**Boral Berrima Cement Works
Modification 9 - Use of Solid Waste Derived Fuels
Response to Submissions**

Report Number 610.15875

22 January 2016

Response to Submissions

Figure 1 GHG Emissions from the Existing and Proposed Project

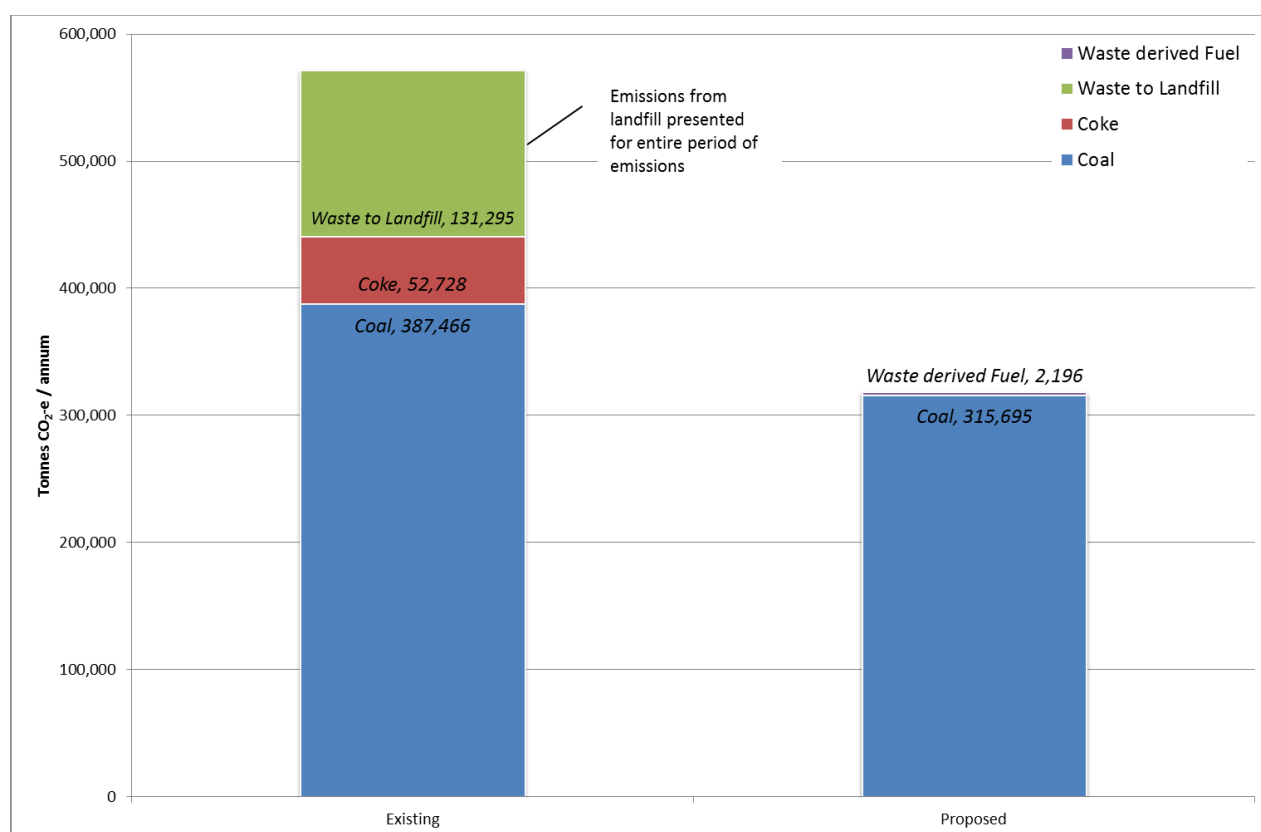
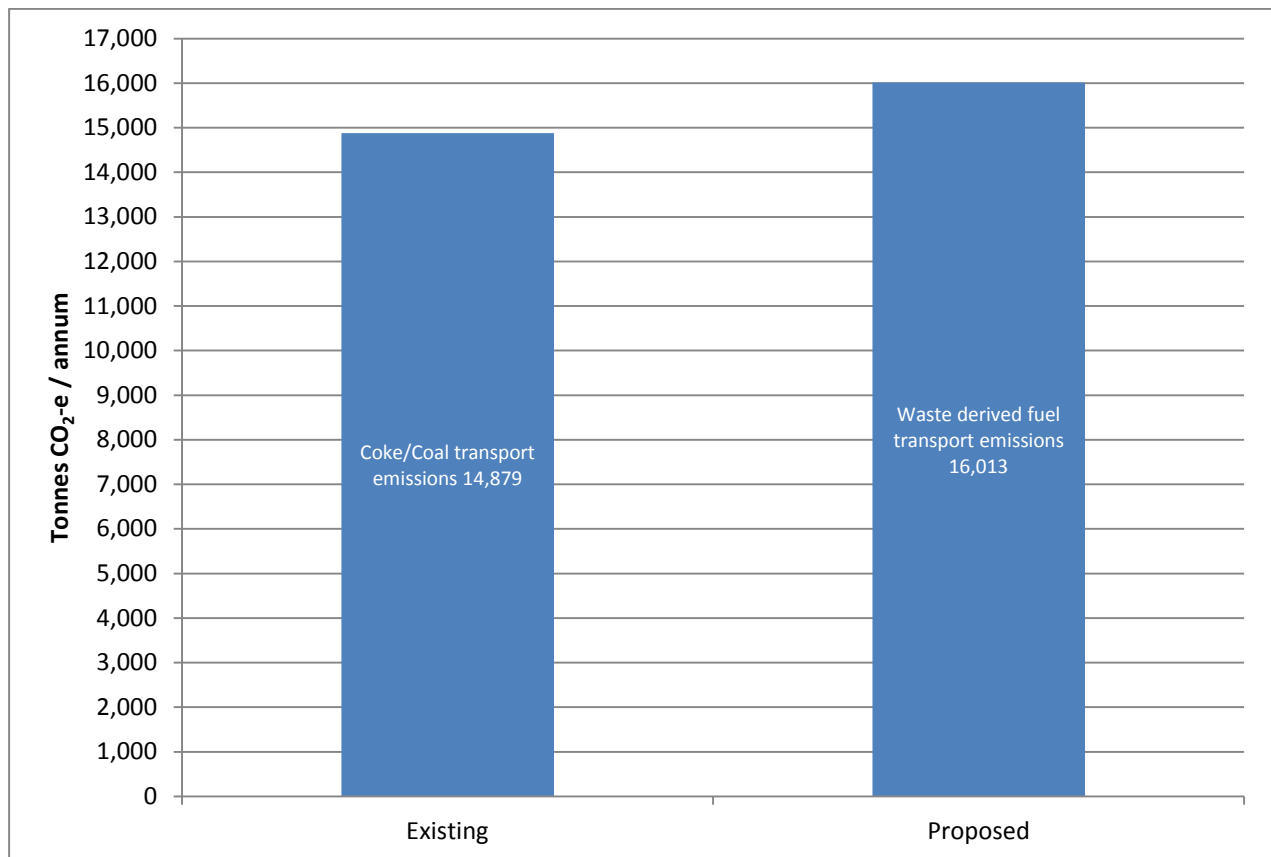
A diagram that sets out the environmental offsets and benefits of the proposal should be included, i.e. use of non-standard fuels, reduced transport of coal, reduced use of coal, less waste to landfill, etc.

The main environmental benefits resulting from the proposal are a significant reduction in greenhouse gas emissions both from the operation of the cement works and the avoided decomposition of waste in landfill, a reduced demand for scarce landfill space, and continued support to the regional economy through direct employment and flow on economic effects. The main environmental risks are associated with potential human health impacts resulting from combustion emissions; however, these have been assessed through the air quality assessment and human health risk assessment to be within acceptable limits when appropriate mitigation measures and operational controls are considered.

The impact on greenhouse gas (GHG) emissions is presented in Section 7.2 of the EA report. On an annual operating basis the net reduction in GHG emissions is **118,814 T/CO₂-e pa**. This is broken down as follows:

The overall change in GHG emissions as a result of the proposal are summarised in Figure 1.

Figure 3 VOC off-white clinker emissions

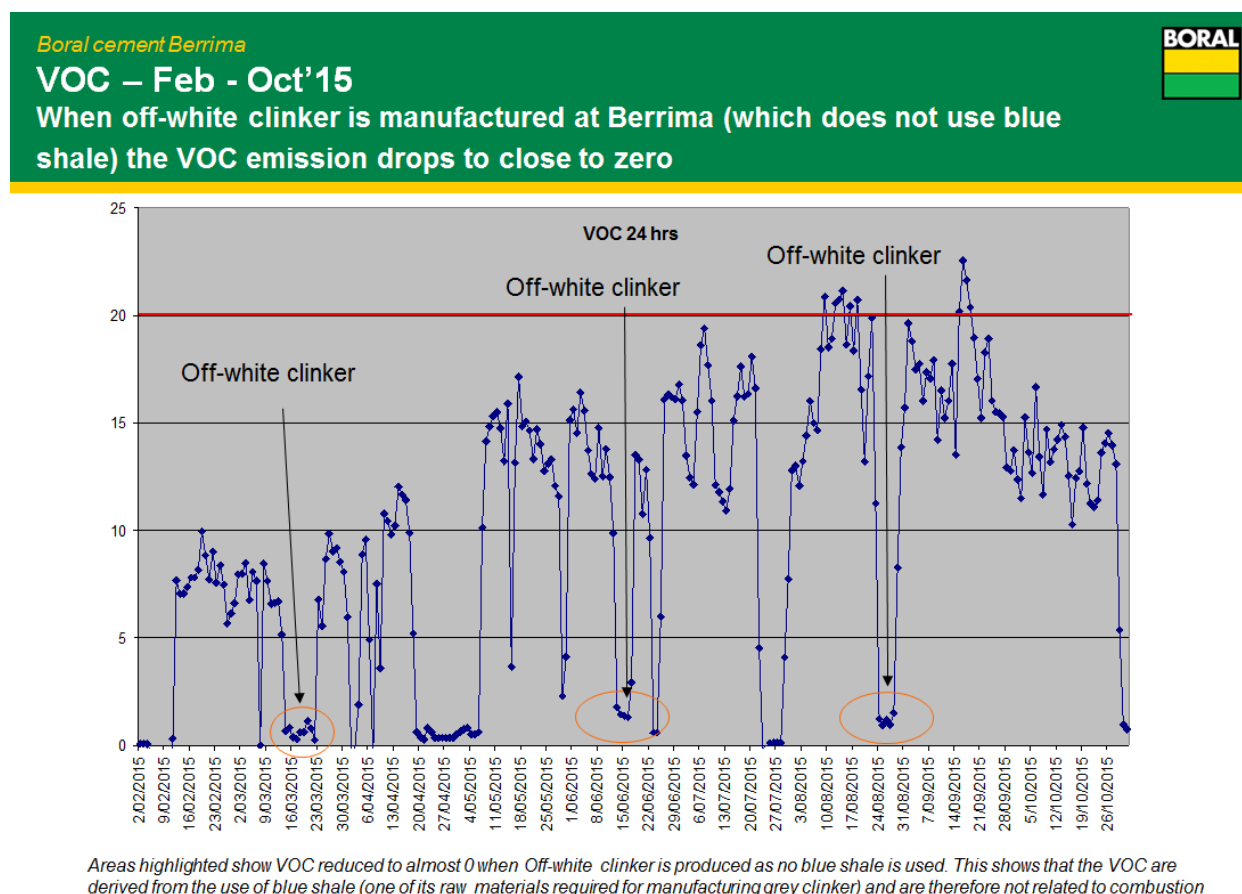
The emission limit value for VOCs (20 ppm) should remain unless the applicant demonstrates that it is physically impossible due to the nature of the raw materials, to achieve this limit, in which case the higher limit sought (40 ppm) could be granted.

In respect of VOCs, Boral provided information in the EA (**Section 4.5.2 and Figure 7**) to demonstrate that VOC emissions at Berrima are derived from the use of blue shale (one of the raw materials required for manufacturing grey clinker) and are therefore not related to combustion. Further evidence is shown in **Figure 3** which demonstrates that when off-white clinker is manufactured in Kiln 6 (where blue shale is not used) the VOC emission drops down close to zero. The graph also demonstrates that VOC emissions vary over time due to natural variation of blue shale within on-site shale pit resource. At times a 20ppm VOC limit will therefore be exceeded even when not using alternative SWDF. It is therefore physically impossible for Berrima to comply with a continuous VOC limit of 20ppm. It is noted that the *NSW Energy from Waste Policy* states (in footnote 2 pg. 6) that "an existing facility may apply to the EPA for an alternative NOx and VOCs emission standard in accordance with clause 36 of the *Protection of the Environment Operation (Clean Air) Regulation 2010*. In view of the above, Boral is proposing to set a practical VOC emission limit of 40ppm, on a 24 hour basis, expressed as non-methane hydrocarbon.
